DESIGN ADVISORY BOARD Tuesday May 24, 2016 at 3:00 PM Conference Room 12, City Hall, Burlington, VT Agenda

MEMORANDUM

To: The Design Advisory Board
From: Mary O'Neil, AICP, Principal Planner
RE: ZP16-1183SP; 311-375 North Avenue
Date: May 24, 2016

Request: Sketch Plan review of site layout and preliminary elevations of multiple structures proposed to be developed at 329-375 North Avenue.

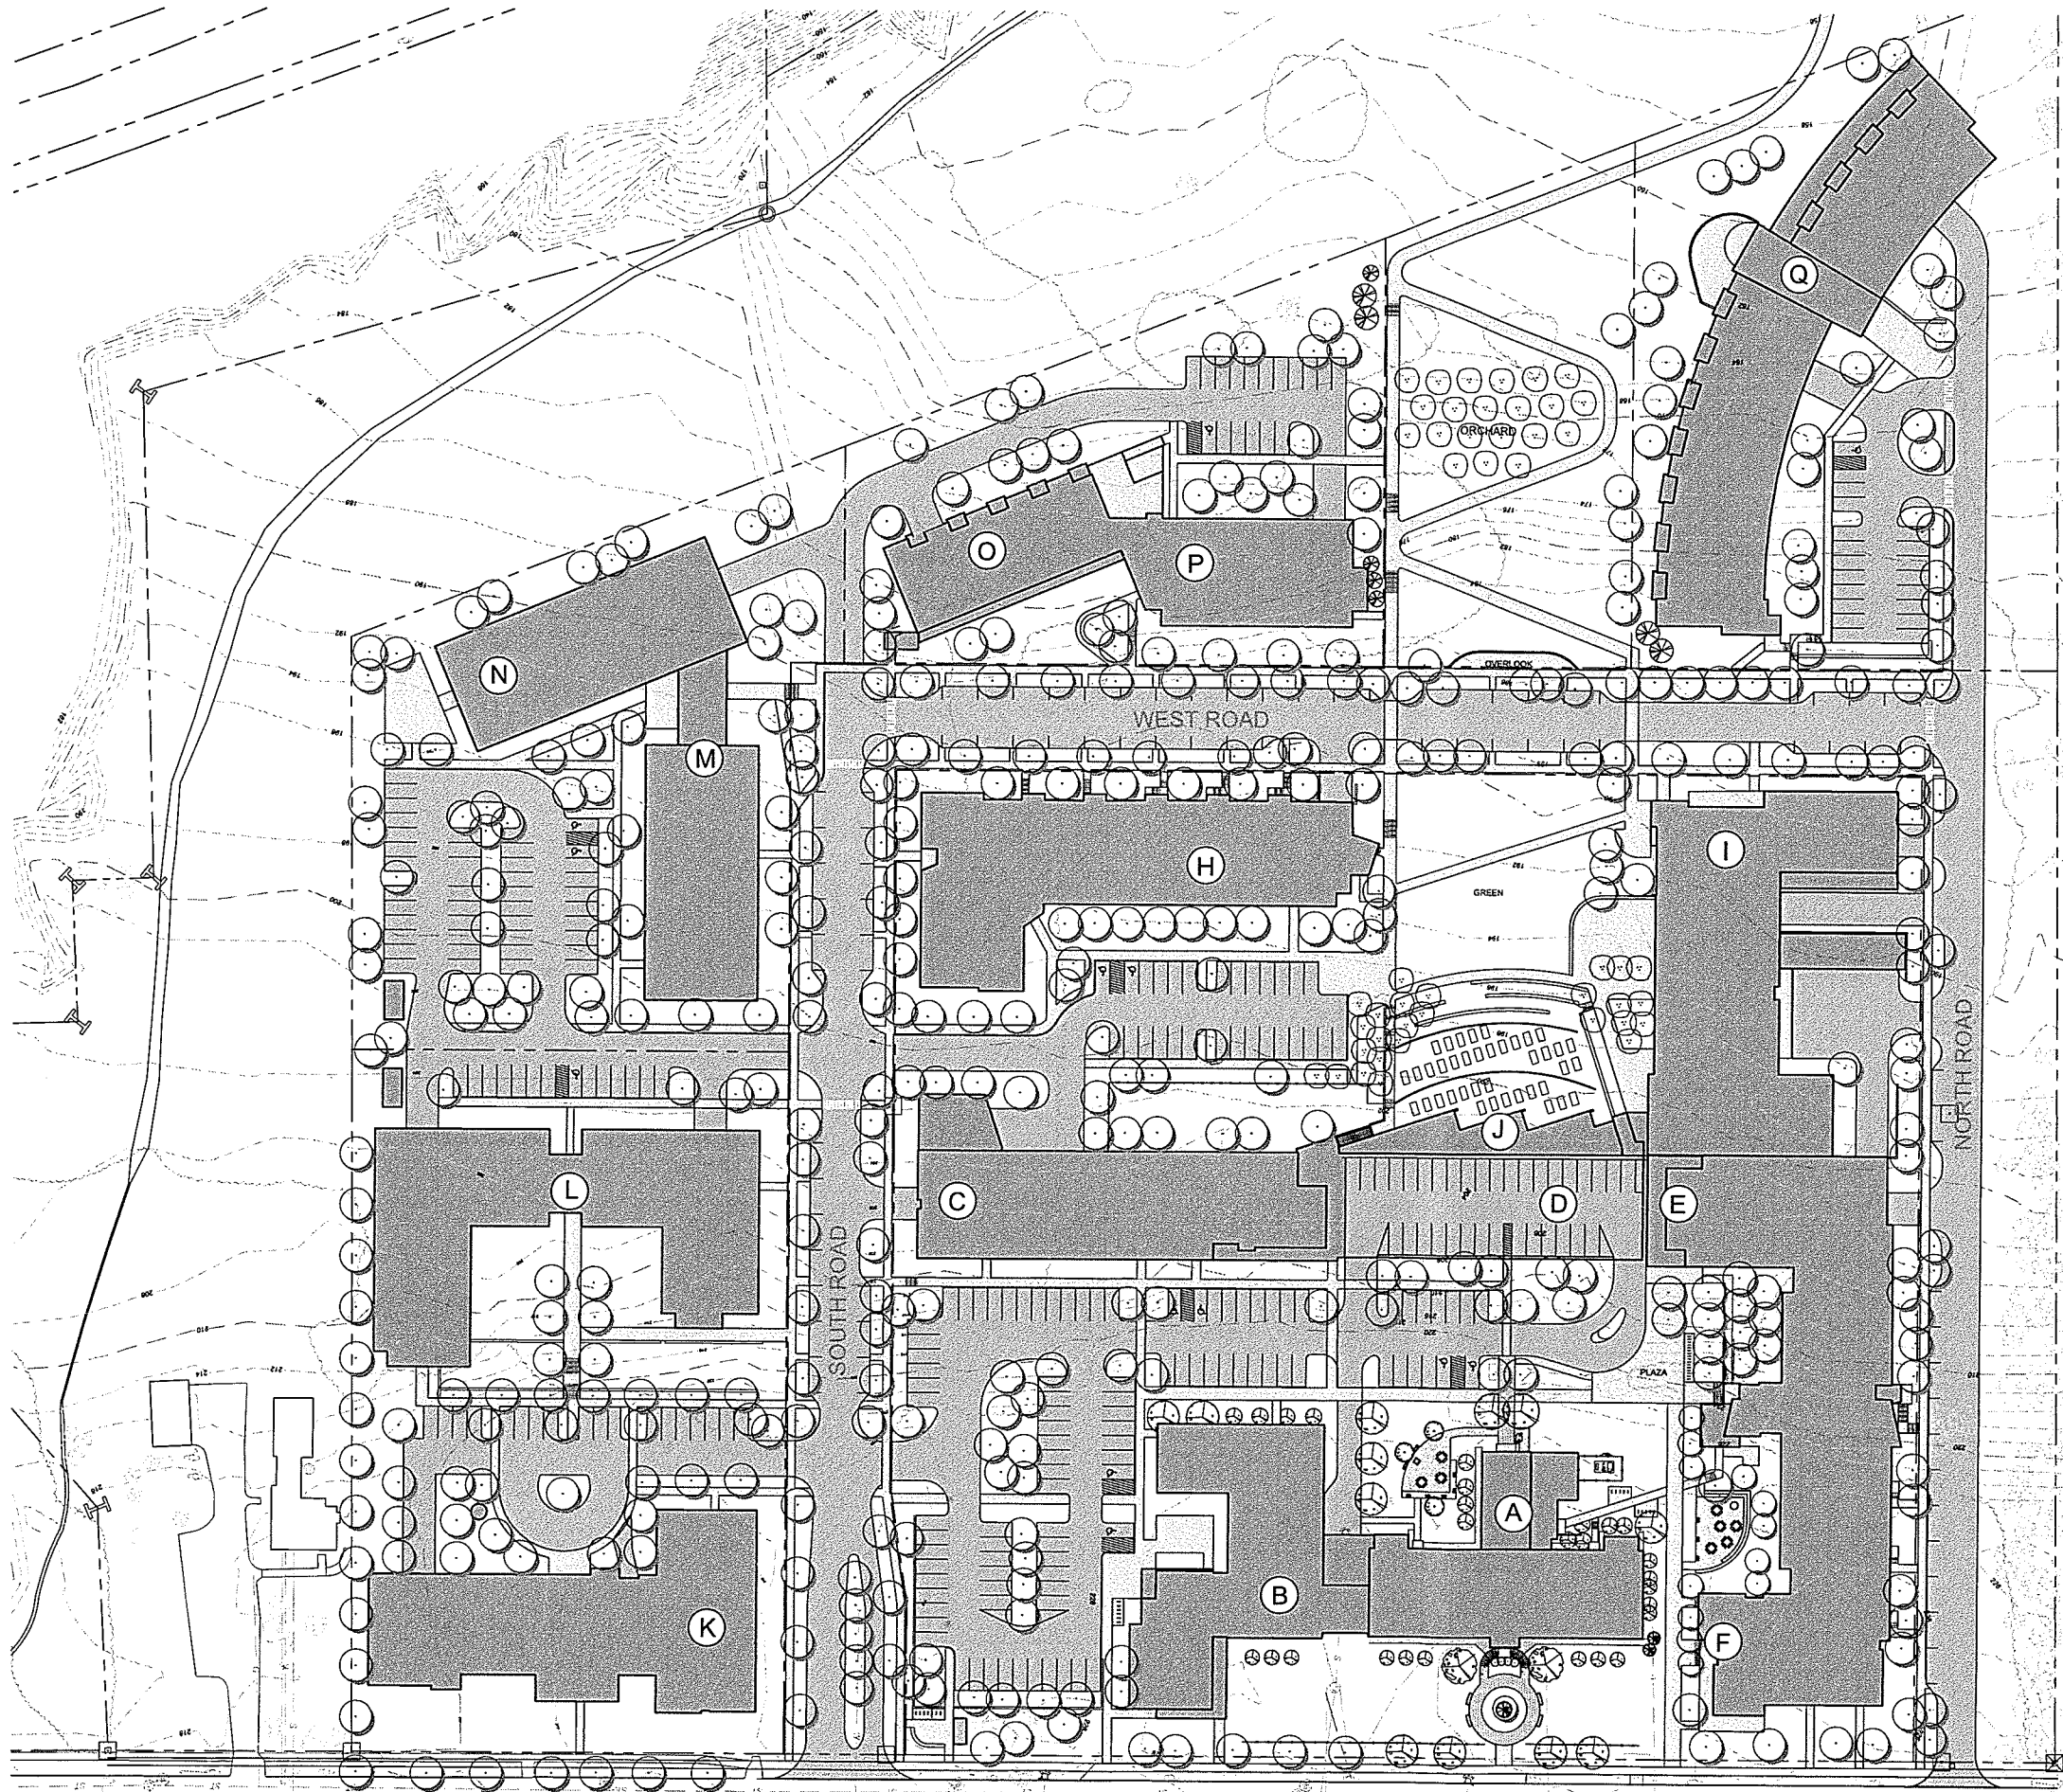
Alternations to the former orphanage have been permitted under previous permits. The former elementary school/priests' quarters on the southerly part of Lot 1 are less sensitive, and are likely to see the addition of a new structure fronting North Avenue. Although massing is illustrated on Plan L-100, no building details have been submitted.
